Elecraft KX3
Tuning Noise Suppression Modification

Revision A, July 2, 2013
Copyright © 2013, Elecraft, Inc. All Rights Reserved

Figure 5. Preparing to Cut Pins 10, 11 and 12.

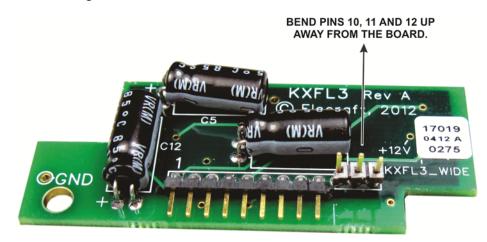
☐ Once the plastic header is cut through, use your needle nose pliers to bend the pins 10, 11 and 12 up away from the board as shown in Figure 5.

Figure 6. Pins 10, 11 and 12 Cut.

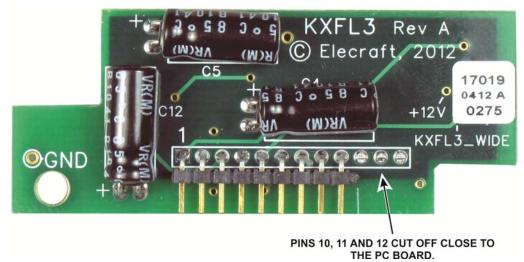
☐ Cut pins 10, 11 and 12 off close to the pc board as shown in Figure 6.
